**CITY OF WILSONVILLE
SECOND AMENDMENT TO CONSTRUCTION CONTRACT****5th Street/Kinsman Road Extension**

Exhibit A - Change Order #02
Pay Item Adjustment

Exhibit B – Change Order #02

Add Standard Curb to PGE Vault 221

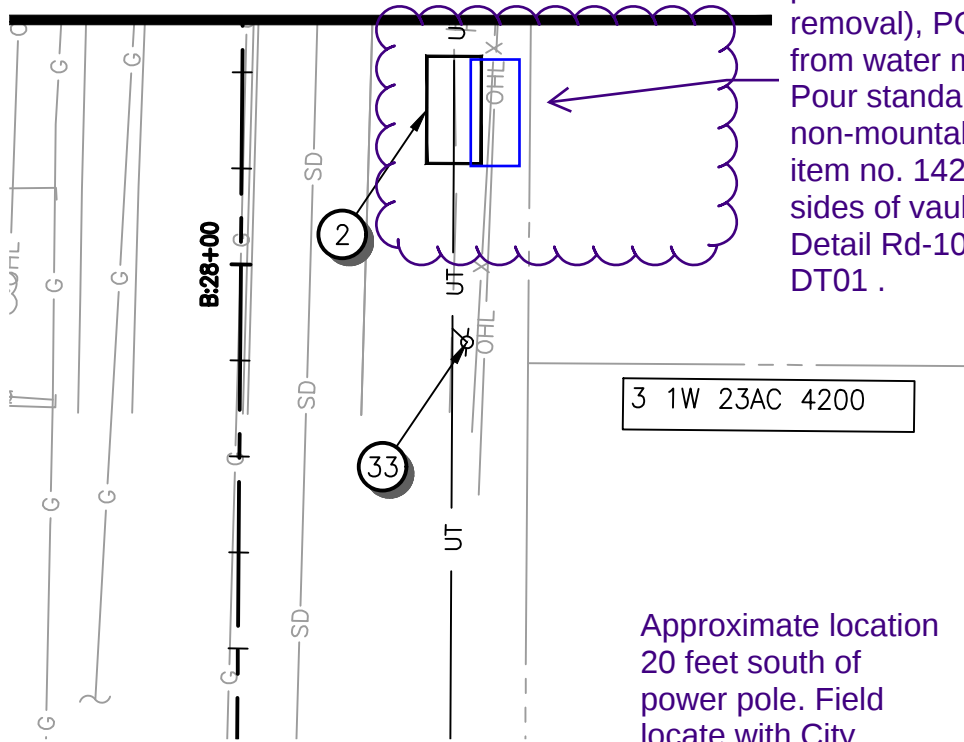
Add Standard Curb to PGE Vault 221 – During construction of the underground electrical infrastructure, PGE requested standard curb be installed along the outside edge of electrical vaults located within parking areas. PGE Vault 221 is located along an unimproved portion of Boones Ferry Road, south of 5th Street within an existing gravel area adjacent to the paved roadway. PGE vault lids are not structurally rated for traffic loading. As a result, PGE has requested standard curb be installed along the south, west, and north edges of PGE Vault 221 to prevent vehicles from driving over or parking on top of the vault lid. The design change is included on page 4 of Exhibit C. This design change results in increased estimated quantity of Pay Item 142 – Non-Mountable Median - Asphalt Streets.

Approximate location for vault 221.
Field adjust based on fence post locations (minimal removal), PGE clearances (2' from water main)
Pour standard 6" non-mountable median (bid item no. 142) around front and sides of vault to protect it - See Detail Rd-1065 on Sheet 122, DT01 .

Pay Item 2001: PGE Vault 5106 Lid Modification

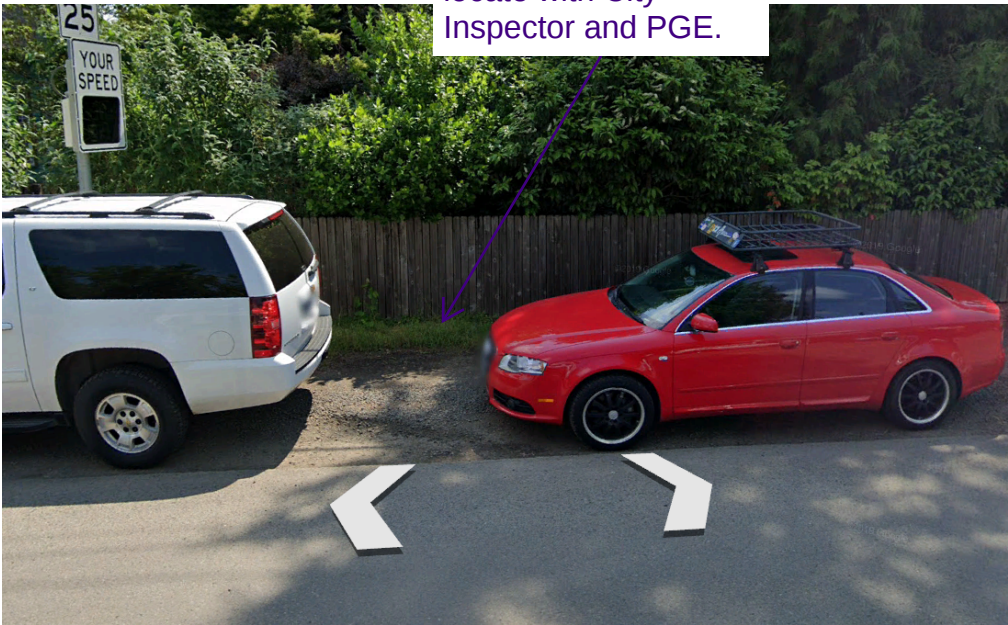
During construction of the underground electrical infrastructure, PGE changed the type of lid and access door required for 5106 electrical vaults located within the public sidewalk and adjacent to on-street parking. PGE requires vault access hatches open and lock at a 90 degree angle in instances where a standard access hatch could fall while opening and be obstructed by or cause damage to adjacent property.

Approximate location 20 feet south of power pole. Field locate with City Inspector and PGE.

The PGE Vault 5106 Lid Modification pay item shall include all additional cost for materials, equipment, and labor to provide and install the modified 5106 vault lids greater than the standard 5106 vault lids that were included as part of the original project construction documents. The cost for this work is considered in addition to Pay Item 72 – Old Castle 5106 Vault and does not result in reduction of existing pay item quantity. This pay item will not be measured in the field and will be paid on the lump sum basis at the Contract price.

Modify Water Quality Facility for PGE Vault 68

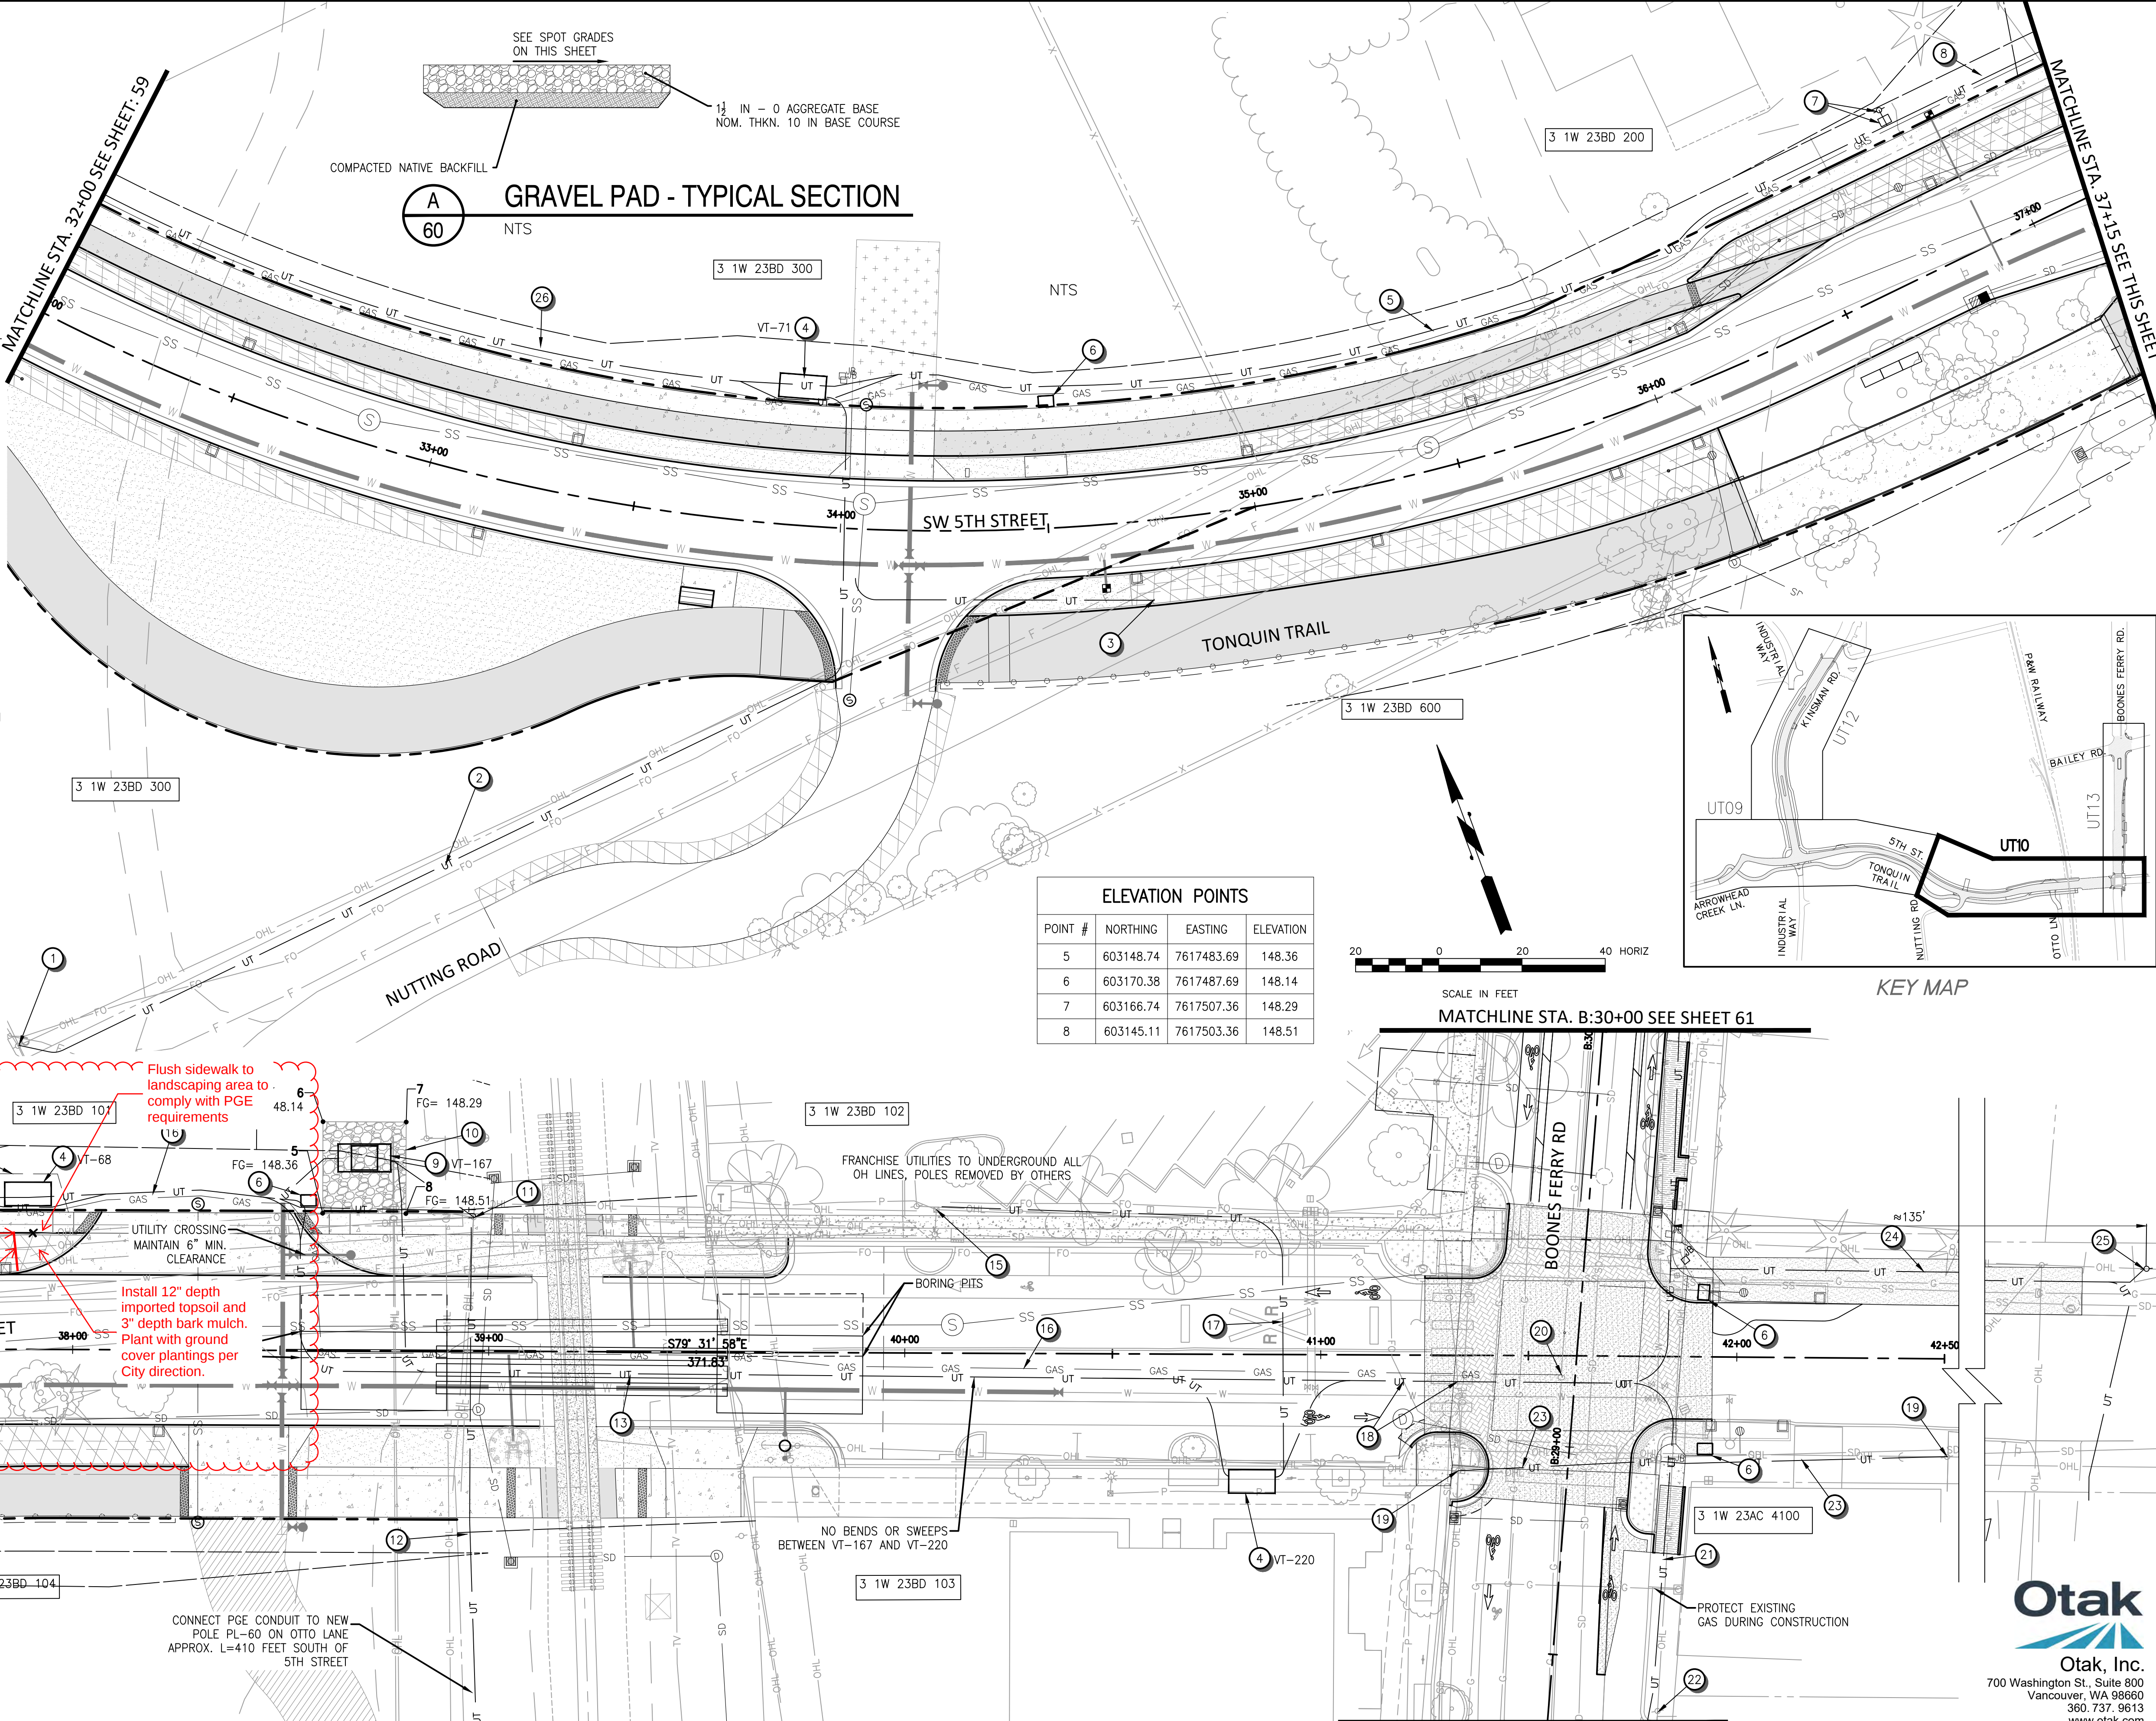
Modify Water Quality Facility for PGE Vault 68 – During construction of the underground electrical infrastructure, PGE requested that the water quality facility located south of PGE Vault 68 be replaced with a standard landscape strip to provide PGE required 10 feet worker safety clearance. The design engineer reviewed the request and confirmed the design change can be accommodated and is documented per Change Order Request #018 (p. 8-11 – Exhibit C). The design change results in a net decreased estimated quantity of Pay Item 148 – Concrete Water Quality Curb and increased estimated quantity of Pay item 141 – Non-Mountable Median - Concrete Street. It is assumed that the difference between backfill, excavation, soil, plantings and all other work not specifically identified in this Change Order No. 2 for the conversion of the water quality swale and the landscape planter strip is negligible for which no separate or additional measurement or payment will be made.

Prior to modification of the water quality facility for PGE Vault 68 as described above, a 12-foot long section of water quality curb had already been installed to the south of the vault. To accommodate the

conversion of the water quality facility to a standard landscape strip, this section of water quality curb needs to be removed.

Joint in Water Quality Curb (approx. location).

Flush sidewalk to landscaping area to comply with PGE requirements

Add new standard planter curb per detail on sheet 072.

Install 12" depth imported topsoil and 3" depth bark mulch. Plant with ground cover plantings per City direction.

The Concrete Water Quality Curb Removal pay item shall include all cost for materials, equipment, and labor to remove and dispose of the identified section of water quality curb. This pay item will not be measured in the field and will be paid on a lump sum basis at the Contract price.

CIP # 4196
PROJECT # 2017-02-001
UT10
60 of 213

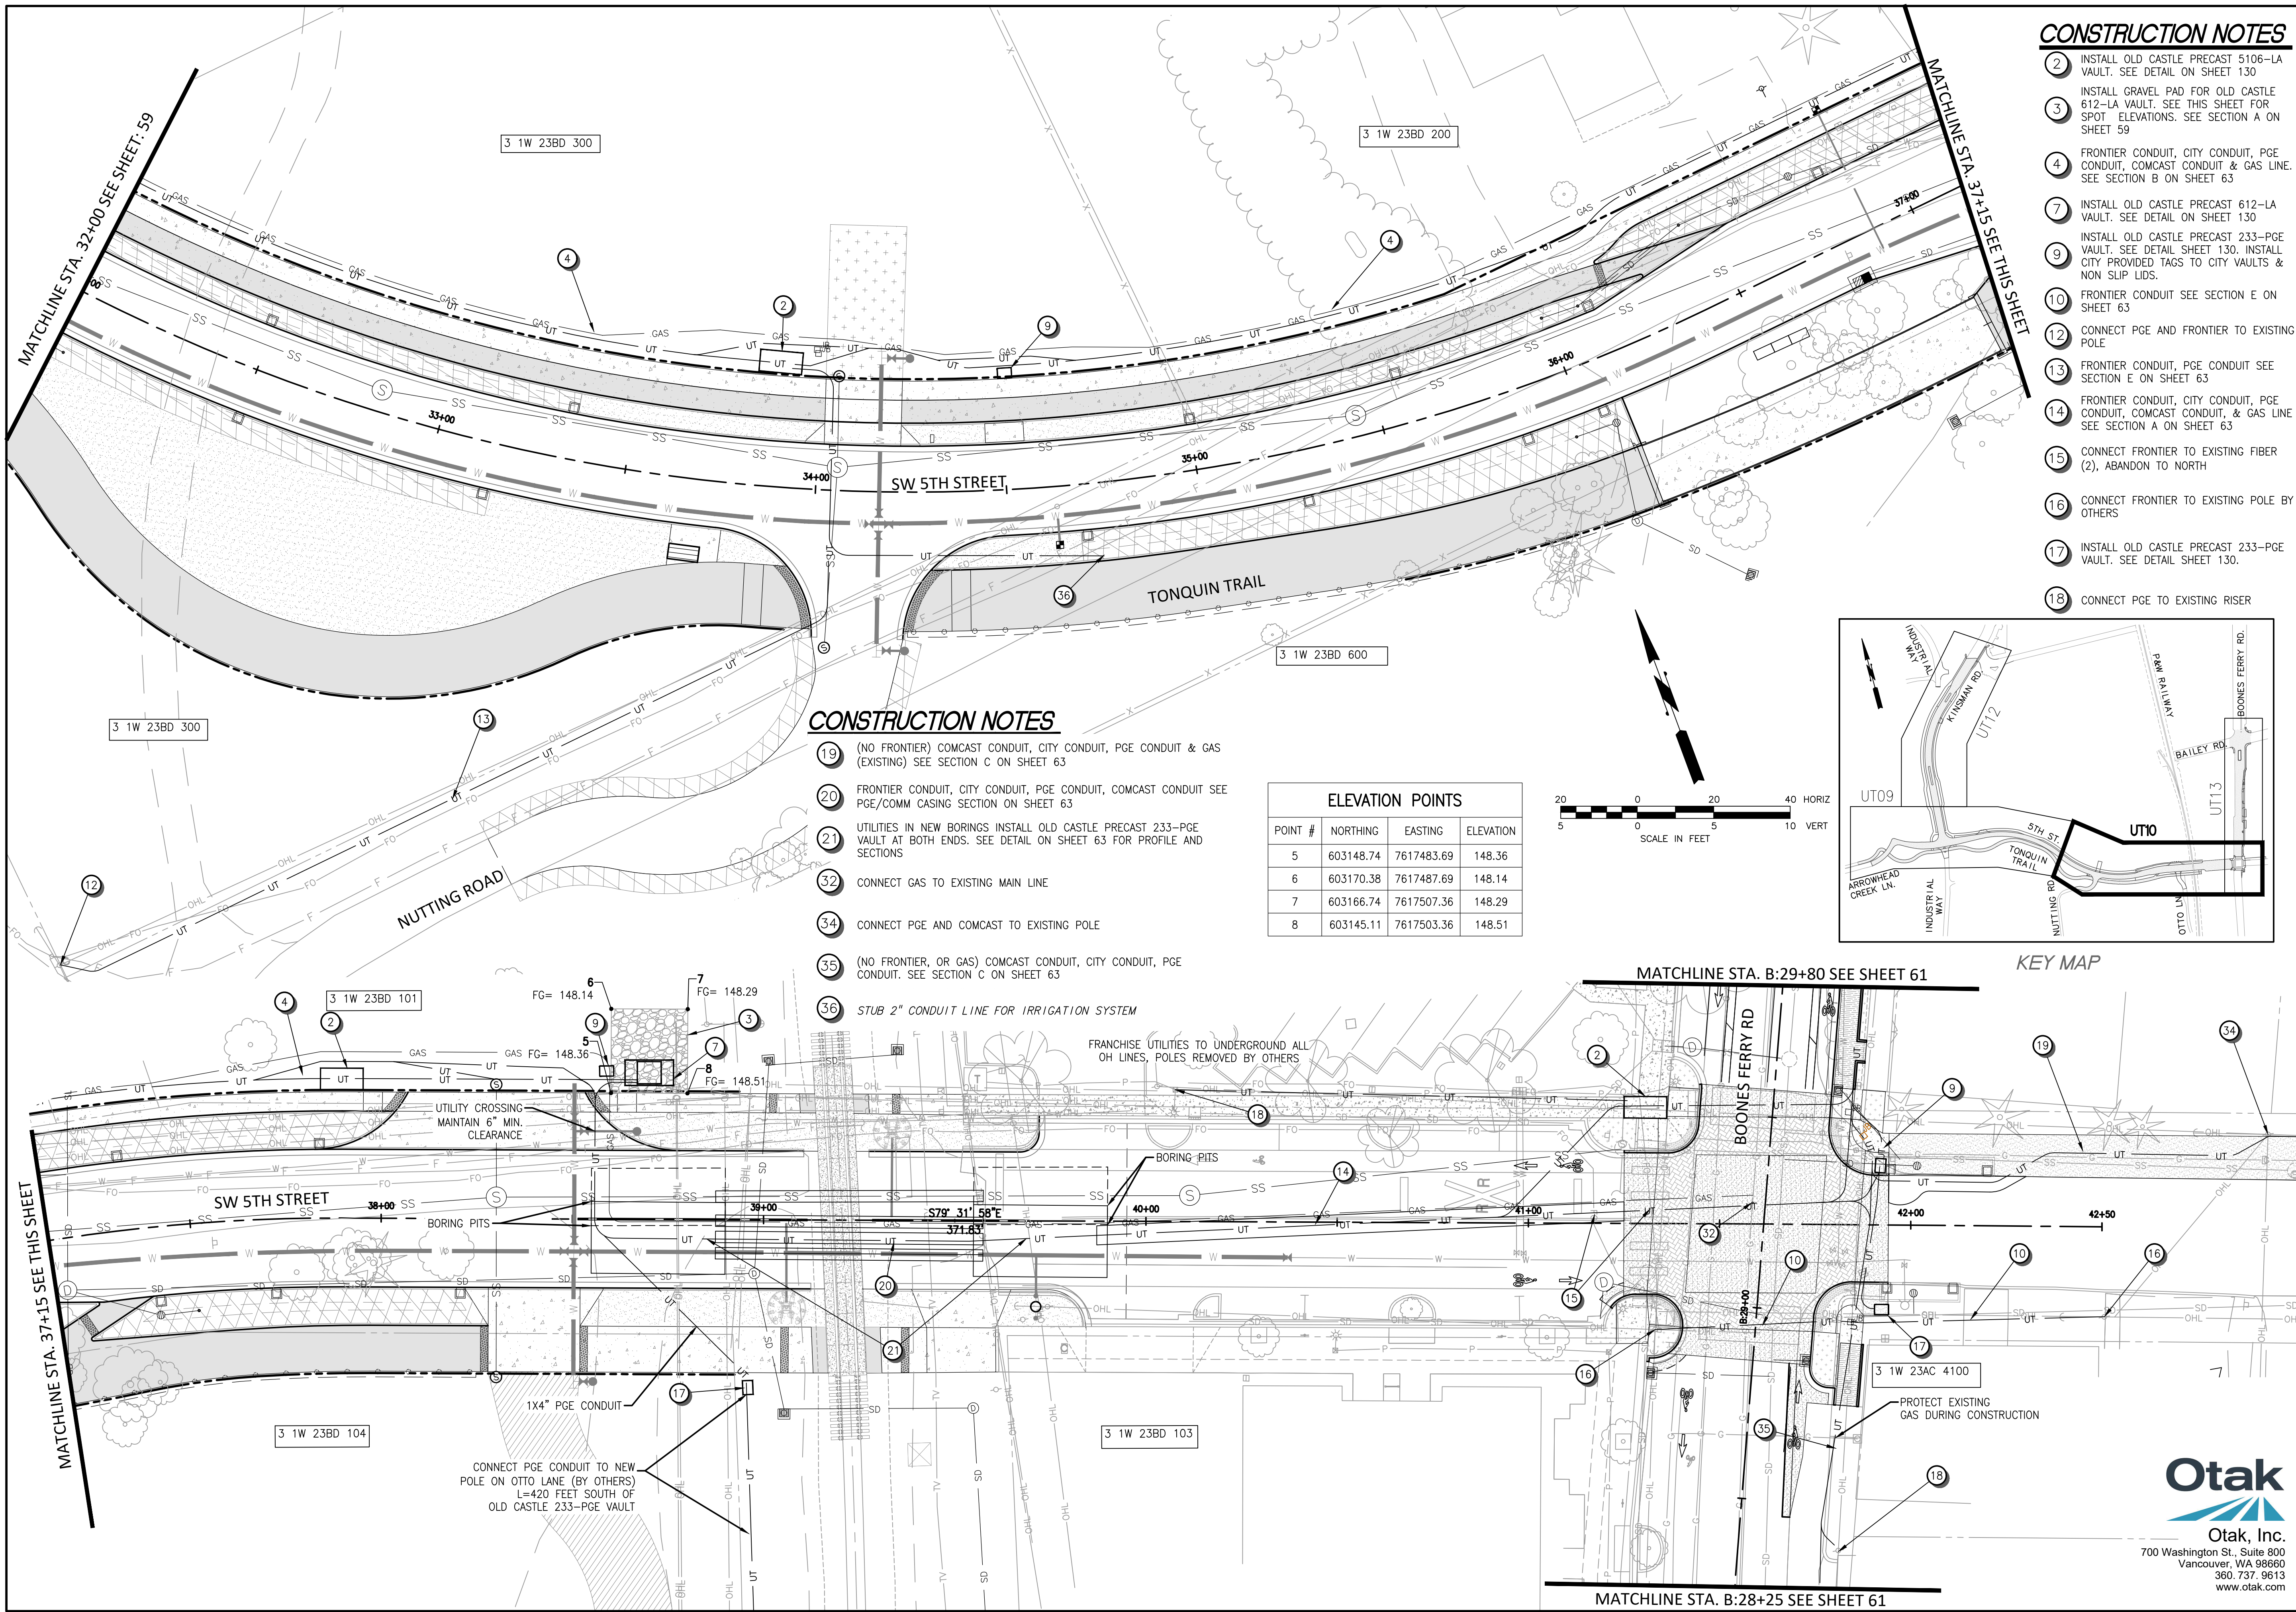
Description of Change(s)					
REMOVE 12-FT SECTION OF CURB IN FRONT OF 612 PGE VAULT; POUR BACK STANDARD CURB; REQUIRED PER PGE SPEC FOR ACCESS TO VAULT (SHEET UT10)					
Item	Description	Qty	Unit	Unit Price	Extension
	3/23/2022	1.00	LS	\$ 745.47	\$ 745.47
	Pay Item 148 - Water Quality Curb	10.00	LF	\$ 75.00	\$ 750.00
	Pay Item 148 - Water Quality Curb	(24.00)	LF	\$ 75.00	\$ (1,800.00)
	Pay Item 141 – Non-Mountable Median	24.00	LF	\$ 42.00	\$ 1,008.00
	TOTAL				\$ 703.47
Terms, Conditions, and Scope Limits/Clarifications					
Additional Time Requested					
N/A
